DEPARTMENT OF THE AIR FORCE  
HEADQUARTERS 377TH AIR BASE WING (AFMC)

Attachment:  
February 8, 2012 FFOR Excavation and Step-Out Conflicts, Addendum to IM WP, BFF,  
March 2011

**Subject: FFOR Excavation and Step-Out Conflicts  
Addendum to Interim Measures Work Plan, Bulk Fuels Facility Spill, March 2011  
Solid Waste Management Units ST-106 and SS-111  
Kirtland Air Force Base, New Mexico**

FIGURE 1

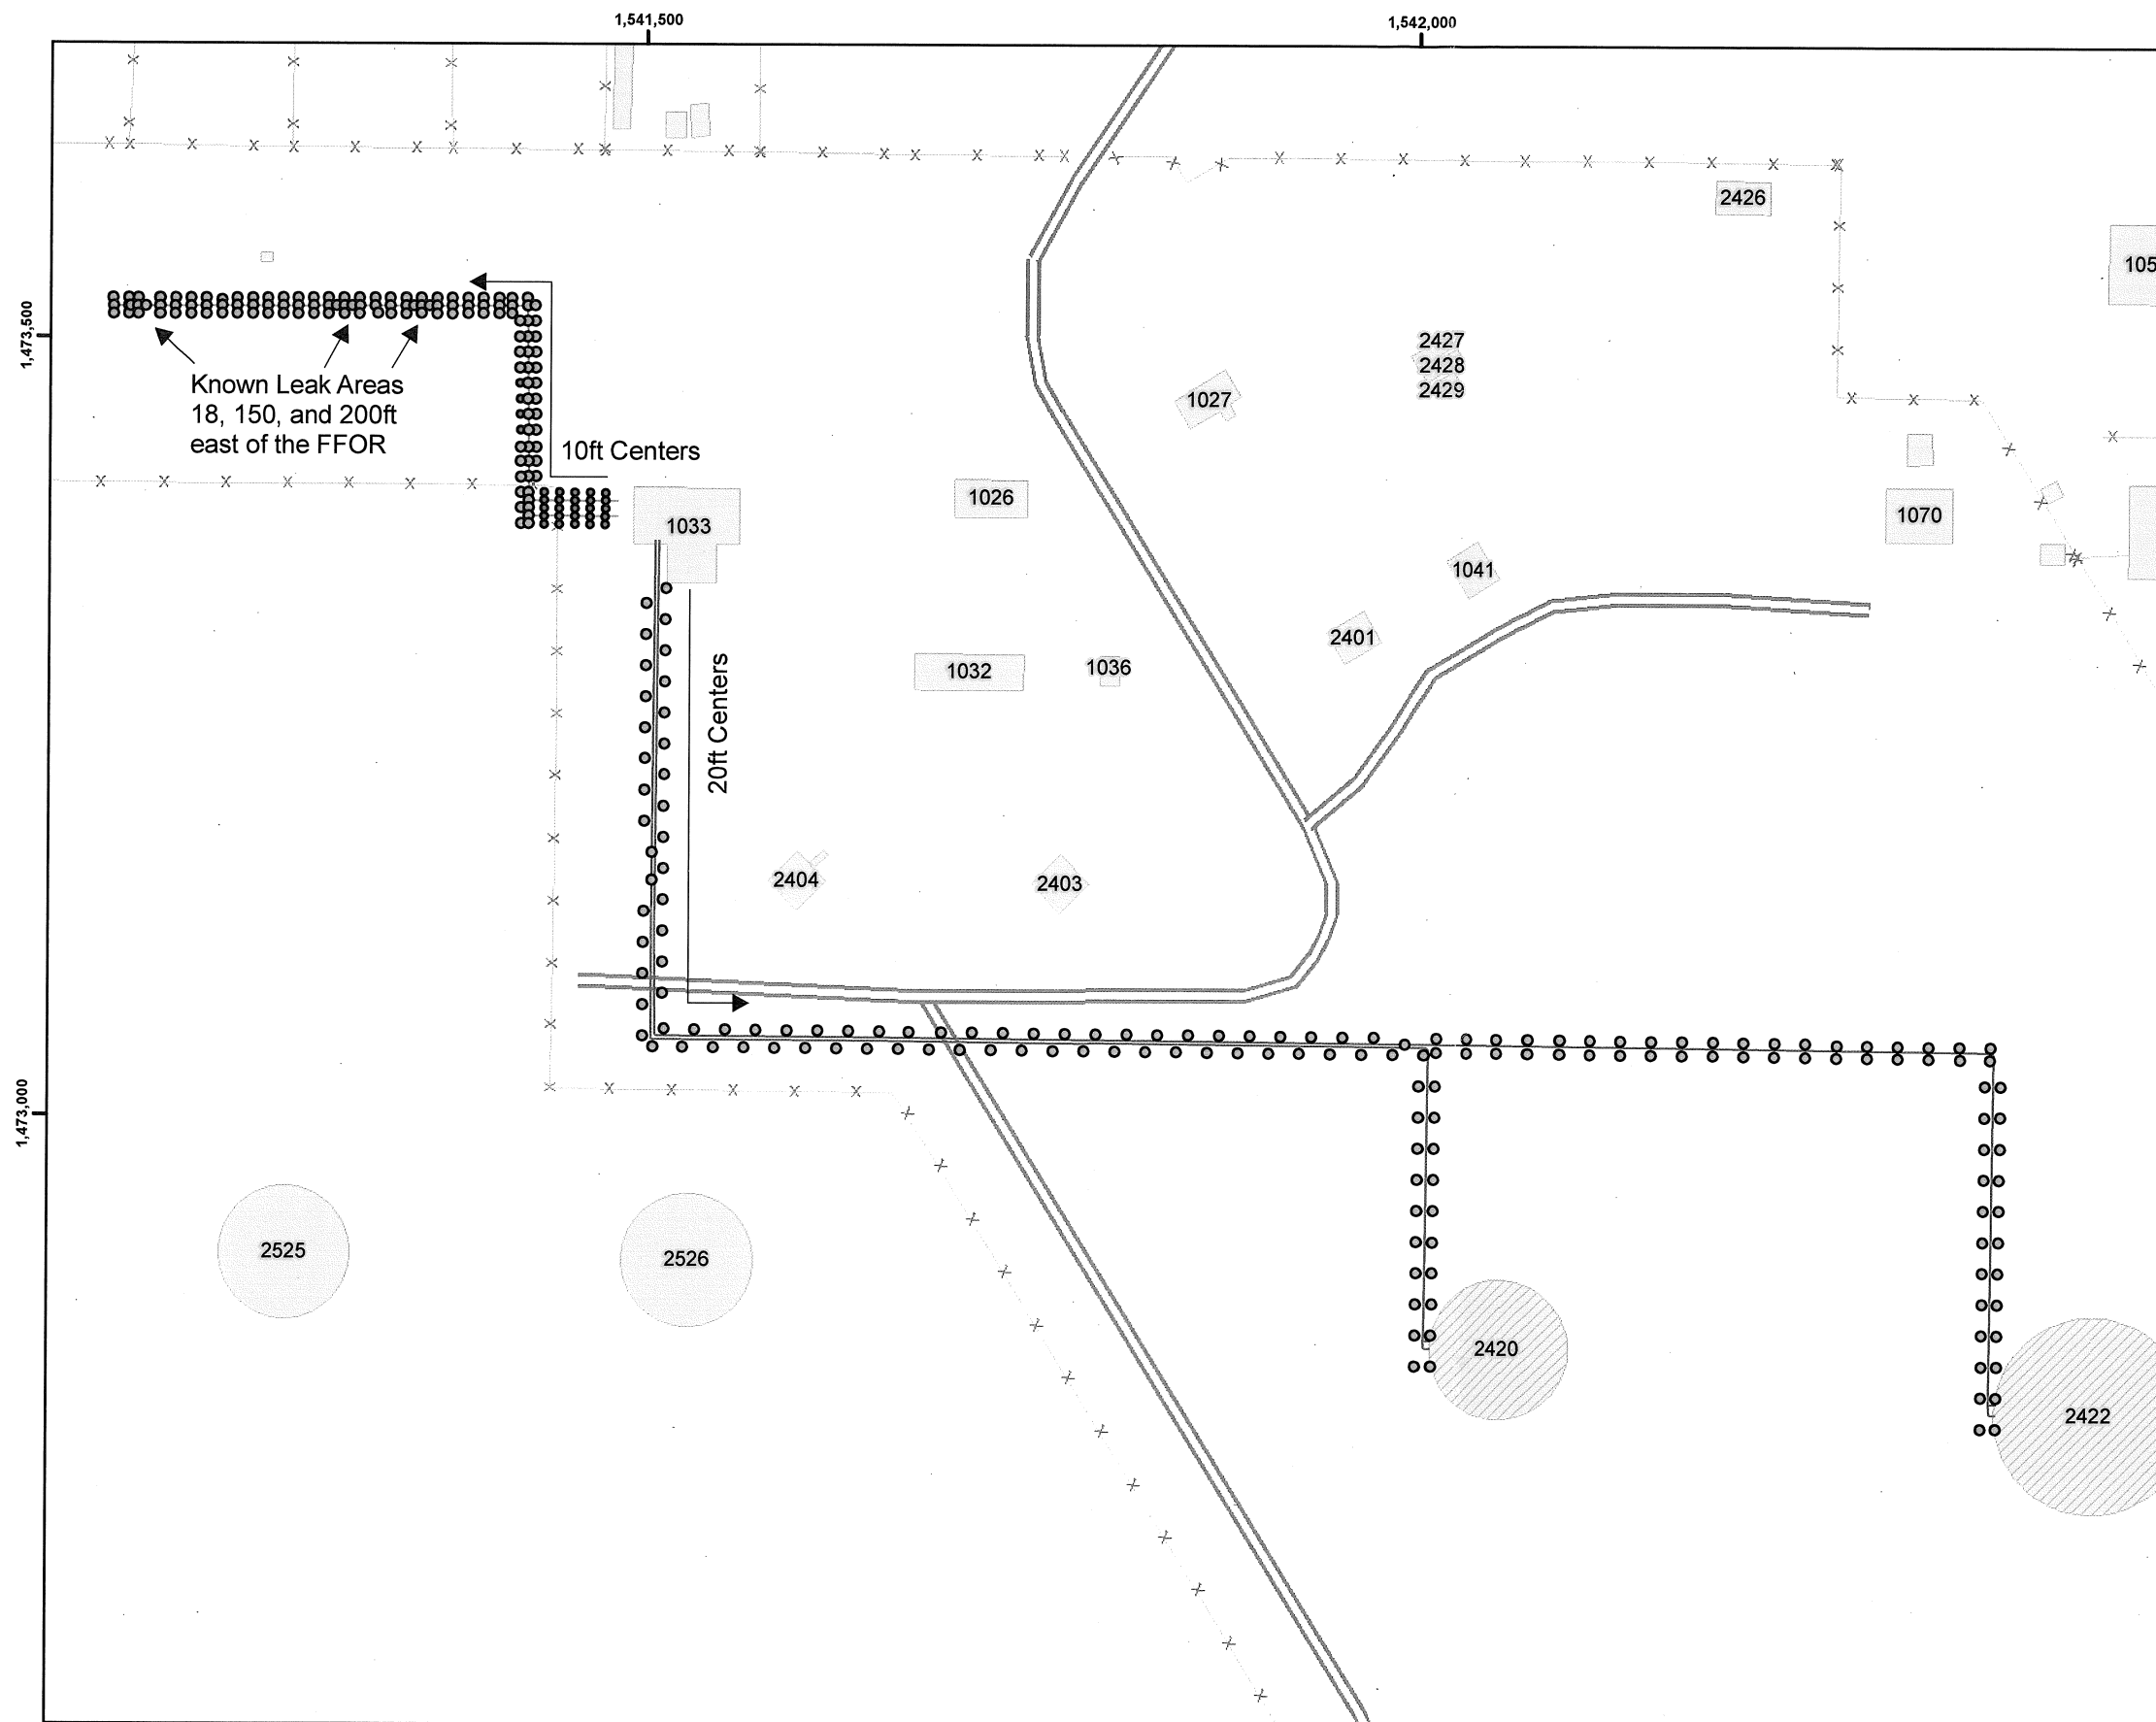
All sampling from the FFOR to Building 1033 and from Building 1033 to the former tanks was completed during this time except for one area directly adjacent to Building 1033 along its west side (Figure 1). Construction was ongoing in this area during the time of the soil investigation. Due to the on-going construction and excavation by Chugach Management Services this area was inaccessible.

FIGURE 2

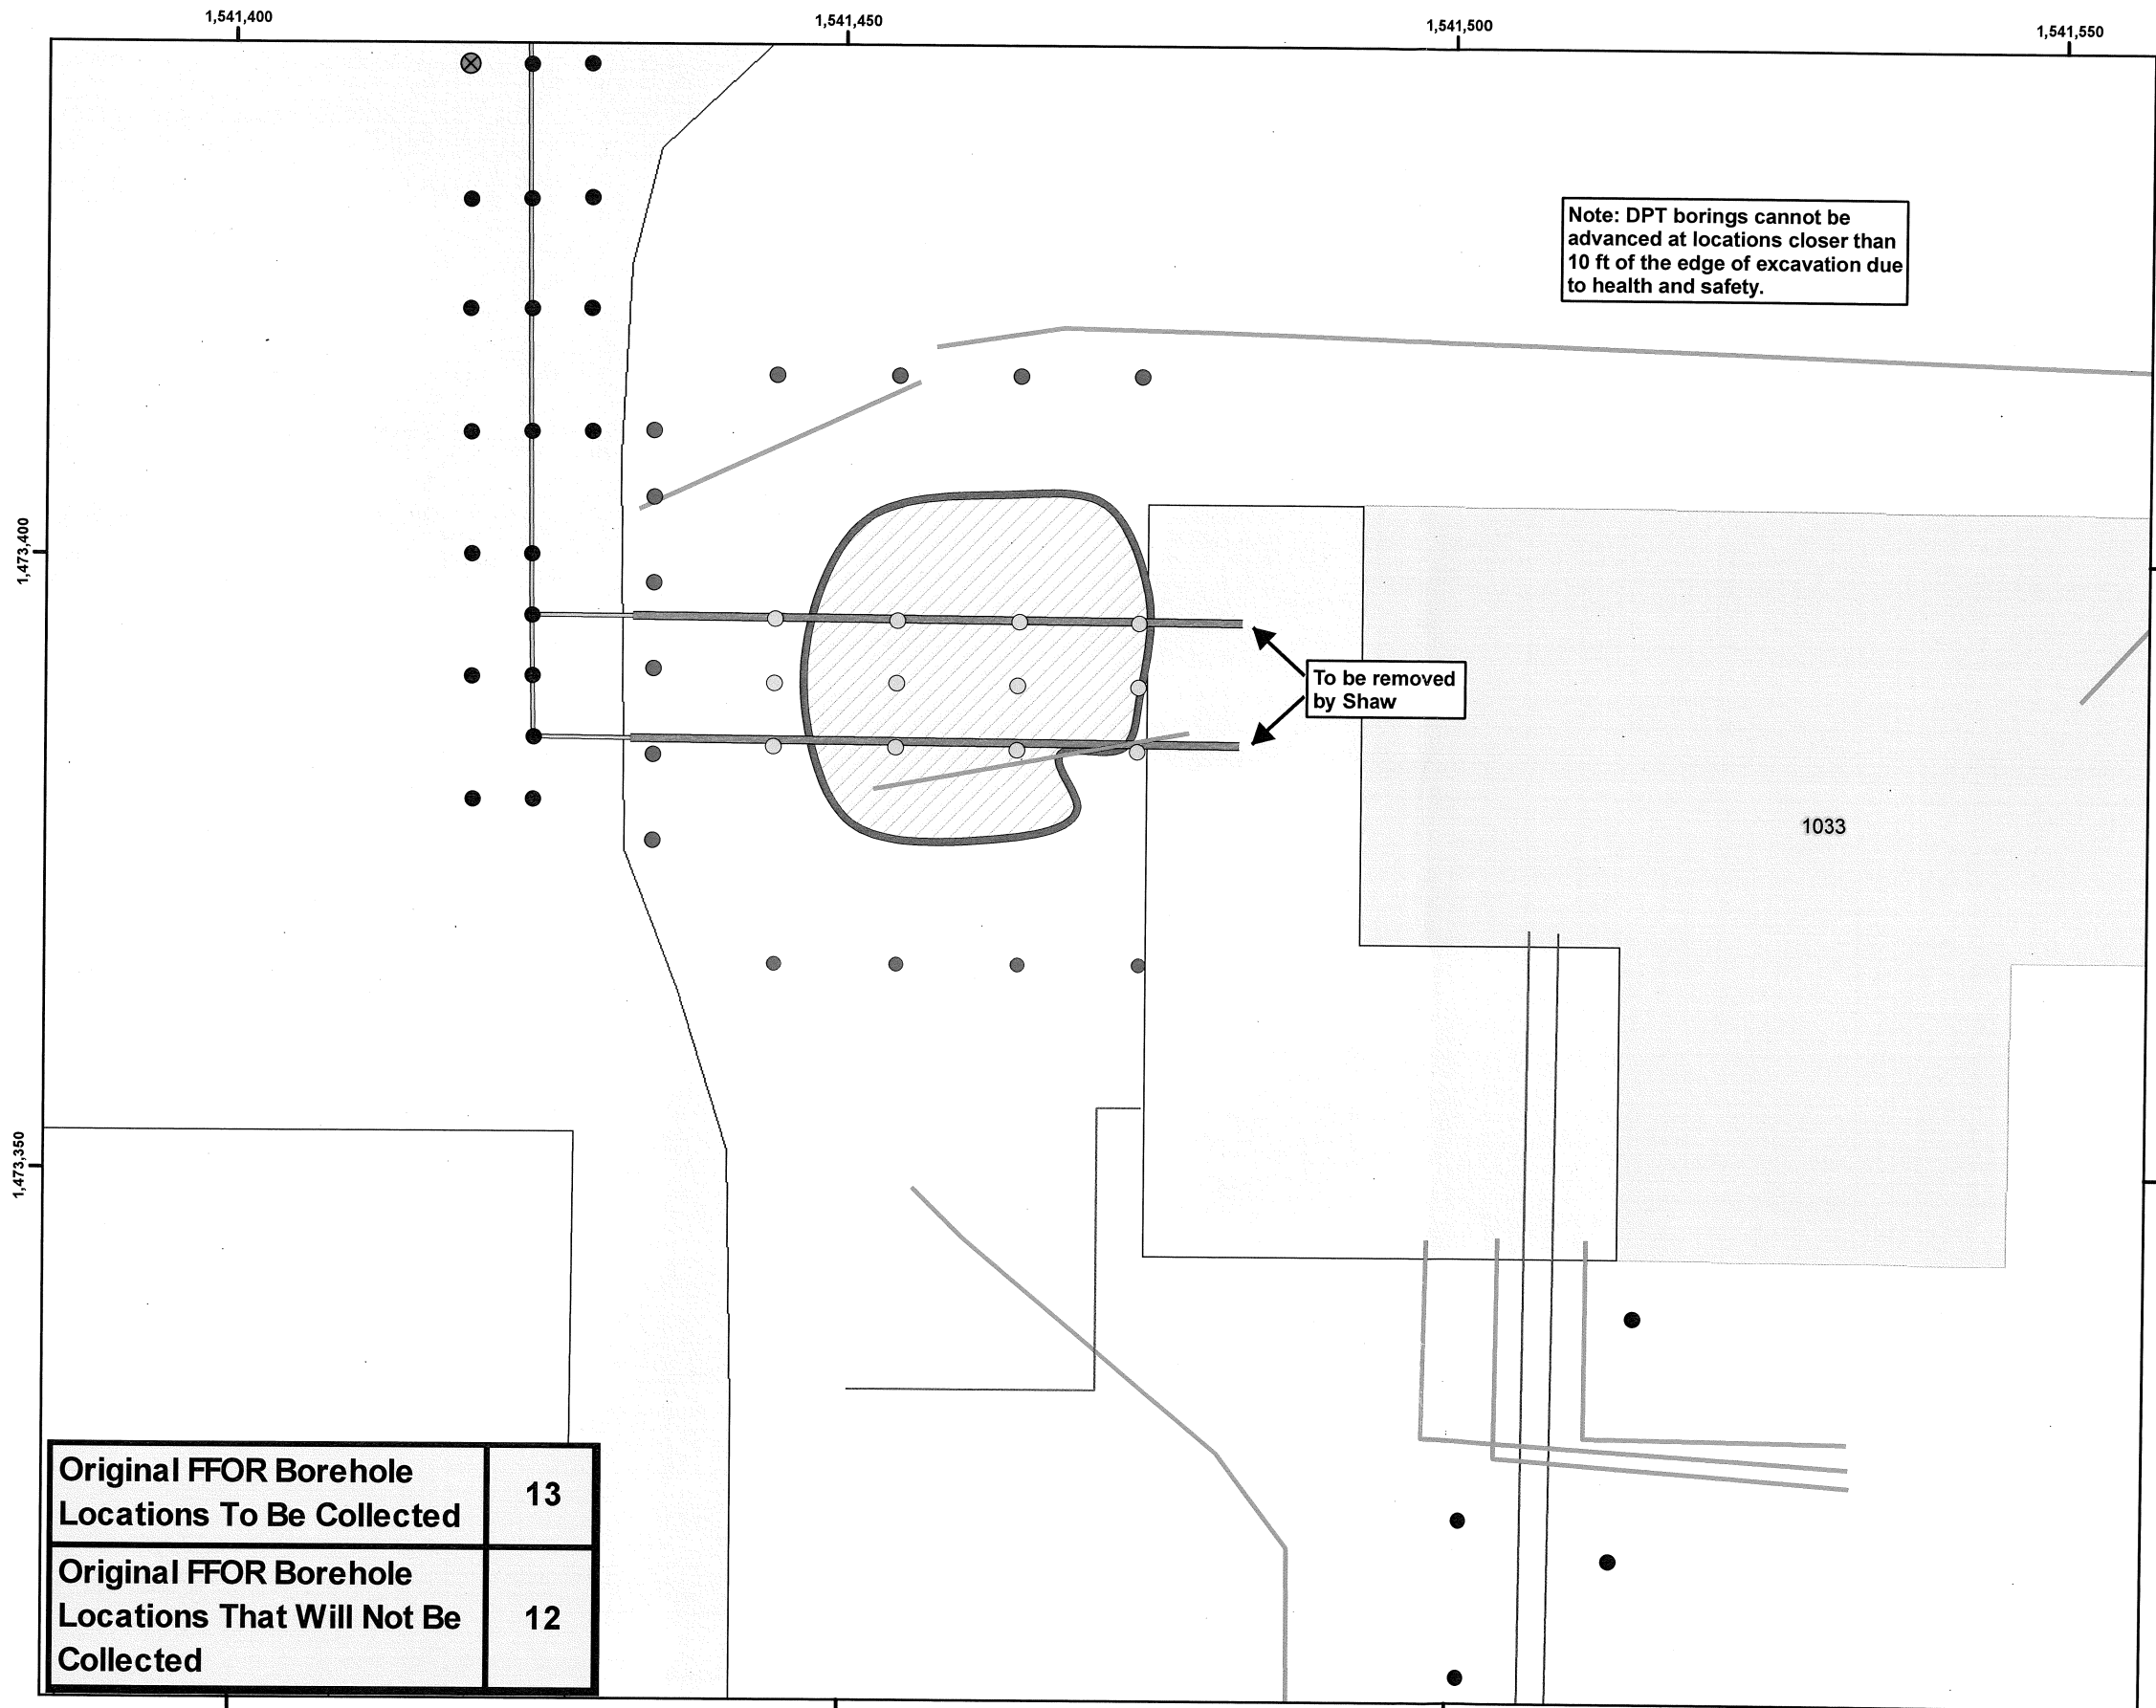
Until January 20, 2012 there was an existing excavation in this location (Figure 2); however this excavation has now been for the most part backfilled. Though the excavation has been backfilled, the soil has not been compacted, and it does not entirely fill the excavation, seeing as some infrastructure has been removed. Collecting DPT samples at the originally proposed locations in the excavation would pose a severe health and safety risk. Furthermore, within the area of the excavation, 0-13 ft bgs (the approximate depth of the excavation) does not represent original material that would have been affected by leaks from the former fuel

lines. Another complication in this area is that the original fuel pipelines, although abandoned, are still in place and extend 30 ft west from the foundation of the pump house to terminate in a concrete slurry. These 16" lines are directly underneath several planned sample locations, making advancement to 20ft bgs impossible.

In order to maintain health and safety standards, and to remain true to the intent of the original soil investigation plan outlined in the Interim measures Work Plan, Shaw proposes to modify the soil boring locations in the area of the excavation (Figure 2) in the following ways:

1. The ten foot spacing between soil borings parallel to the former fuel lines will remain the same. Spacing between soil borings perpendicular to the fuel line will be slightly spread out so that full advancement of all borings is possible around the in-place fuel lines.

2. Any remaining soil borings that are not in the area of the excavation will be collected as stated in the Interim Measures Work Plan.
3. Following advancement of the soil borings, Shaw will re-excavate the area of the excavation to twenty feet and collect confirmation soil samples on the sidewalls and floor as stated in the Interim Measures Work Plan.

4. In order to excavate the area, it will be necessary for Shaw to remove the in-place fuel lines back to the pump house foundation.
5. Following removal of the fuel lines, excavation, and sampling, Shaw will fill the excavation with clean backfill as outlined in the Interim Measures Work Plan.

Note: Following removal of fuel lines, the current excavation will be fully removed to 20 ft.
